STATUS CODE DESCRIPTION
ISSUED FOR FURTHER INFORMATION

PROJECT
ADAMSTOWN STATION BLOCK G

DRAWING
GENERAL ARRANGEMENT - LEVEL 08 - EIGHT FLOOR PLAN

PROJECT NUMBER	DATE	
950749	13/08/21	
SCALE@ A1:	DRAWN/CHECKED:	
As indicated	EA/DB	
STATUS CODE:	DRAWING NUMBER	REVISION
A1	ADC-HJL-G-08-DR-A-1018	P04

1 GA - 08 - EIGHTH FLOOR - PLANNING
1 : 200

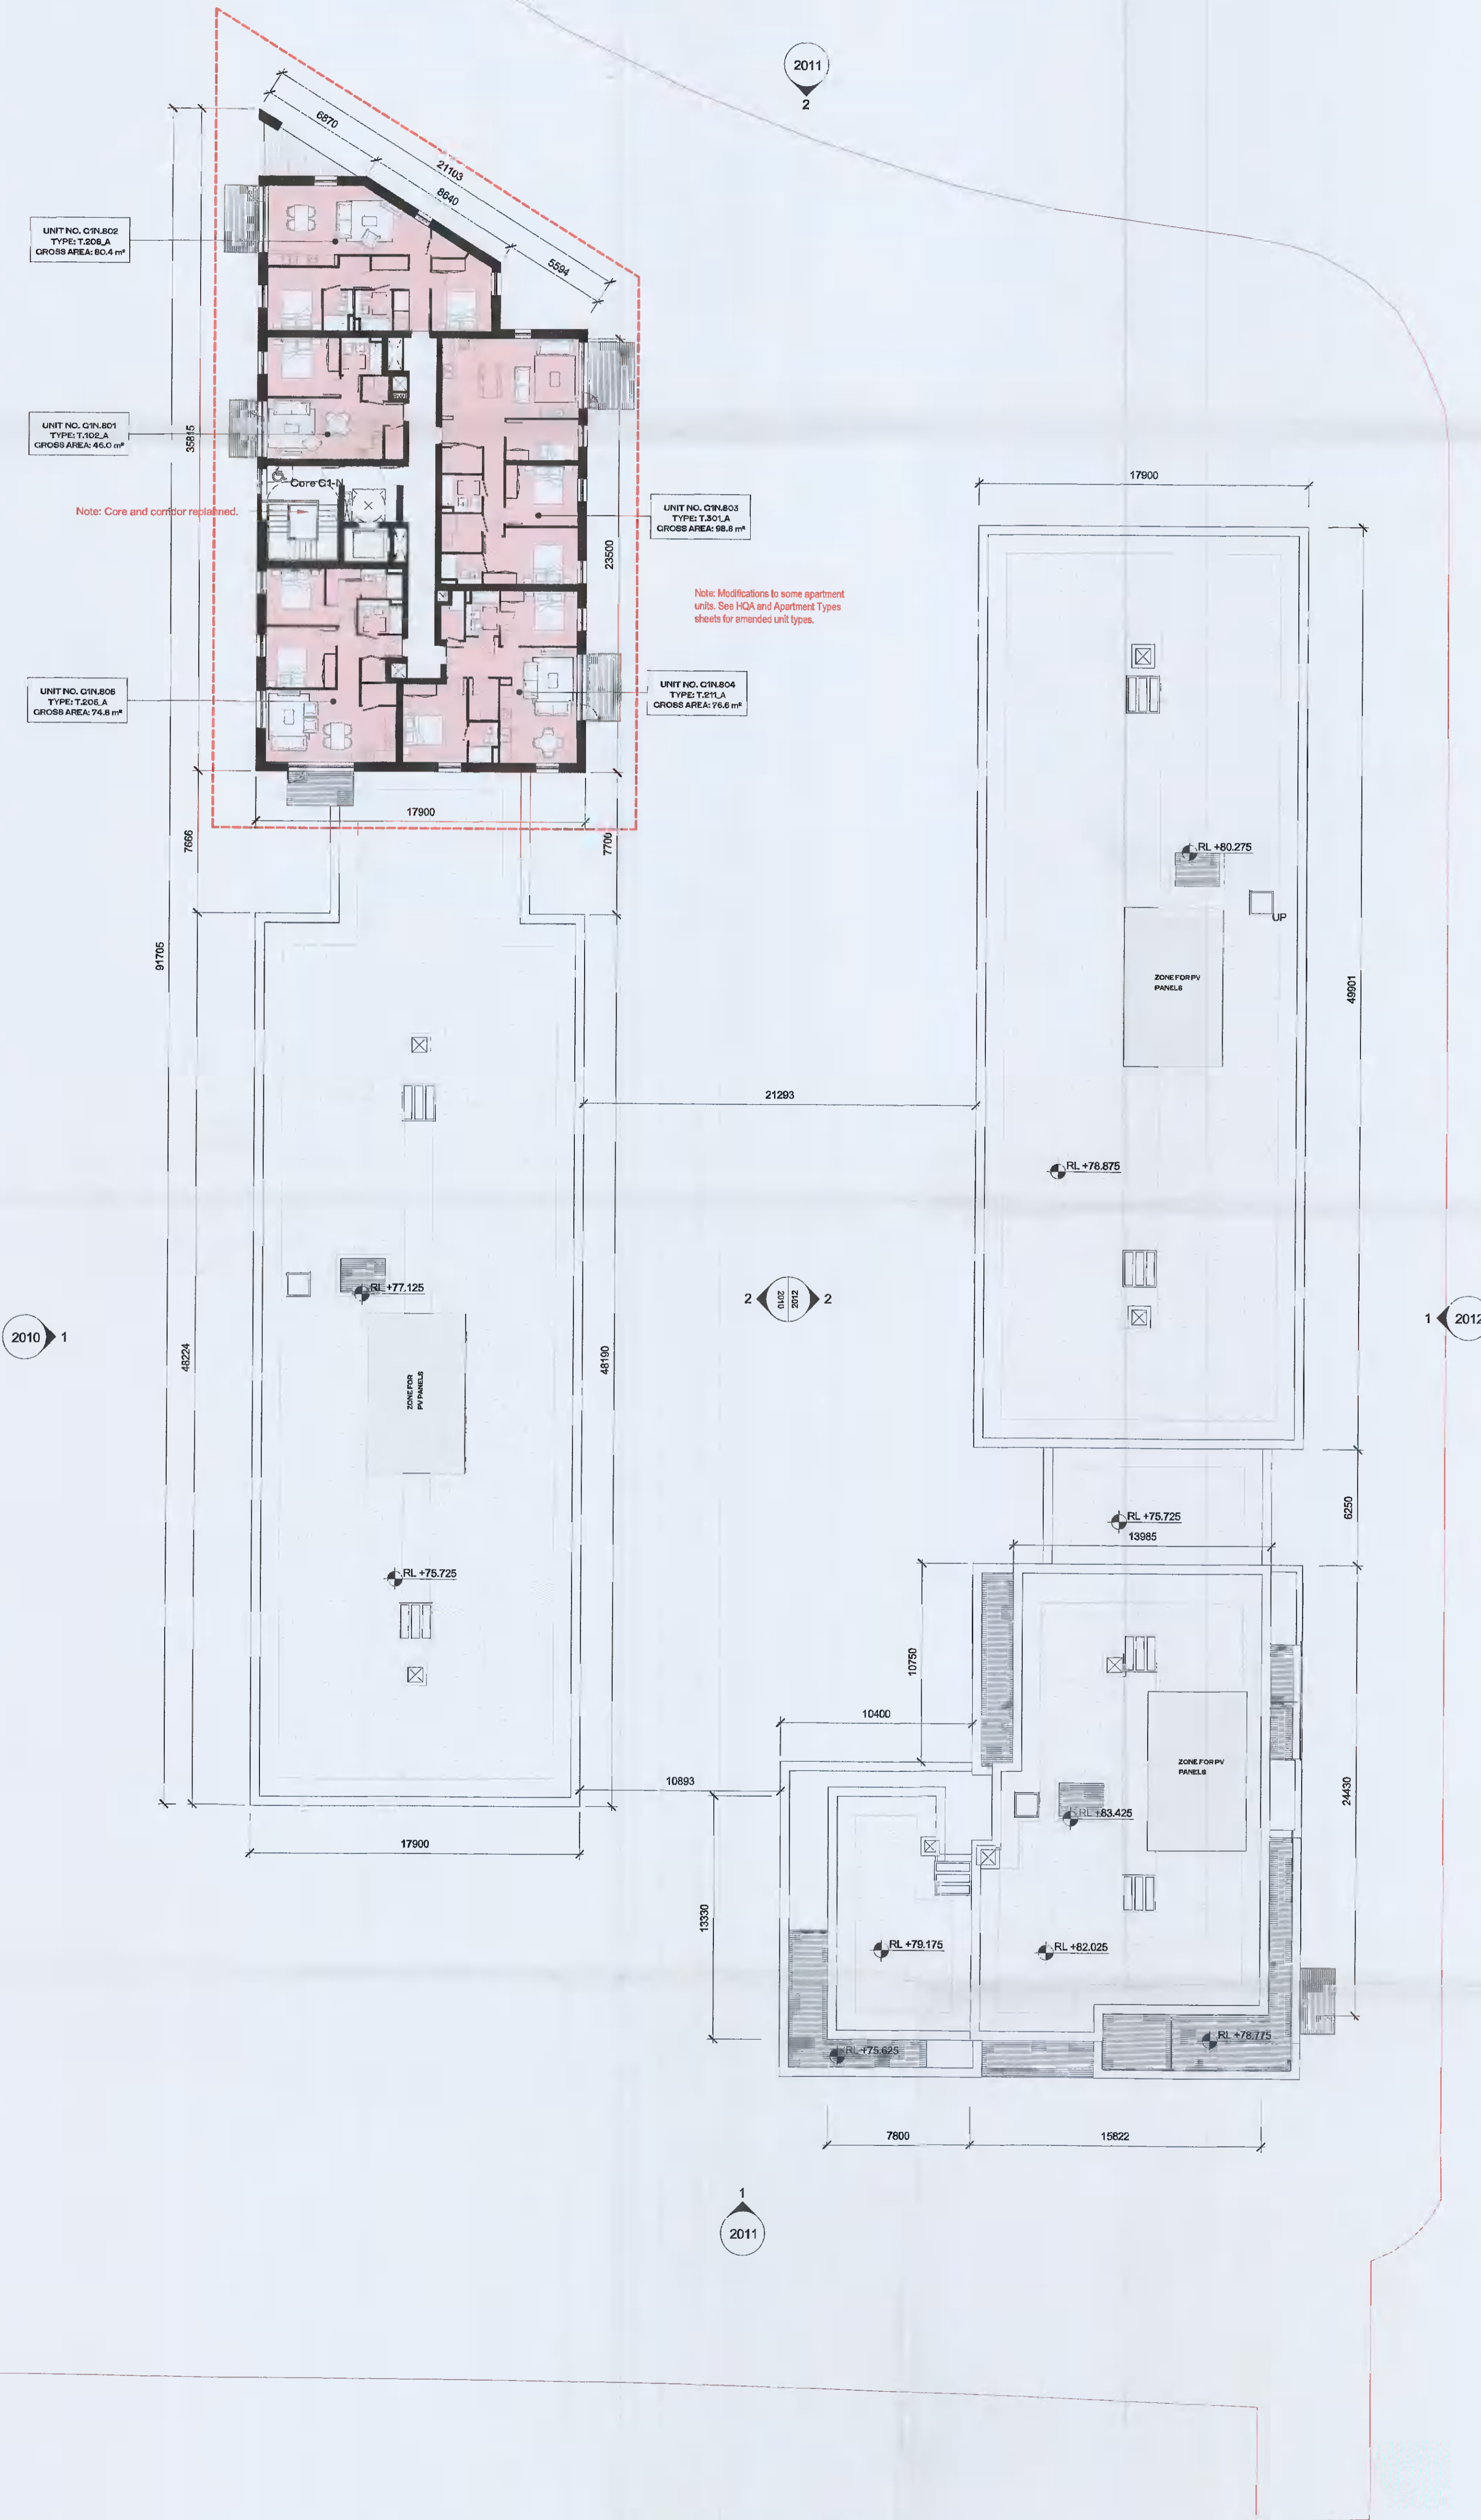
RFI no. 1. (a)

Major Modifications:
Removal of corridor access to podium on first floor and adjustments in size and shape of other residential Units

Minor Modifications:
Marginal adjustments to Unit dimensions and areas, pertaining mostly to unit layout widths or lengths reset due to a modified structural grid

RFI no. 1. (d)

A Residential Unit introduced
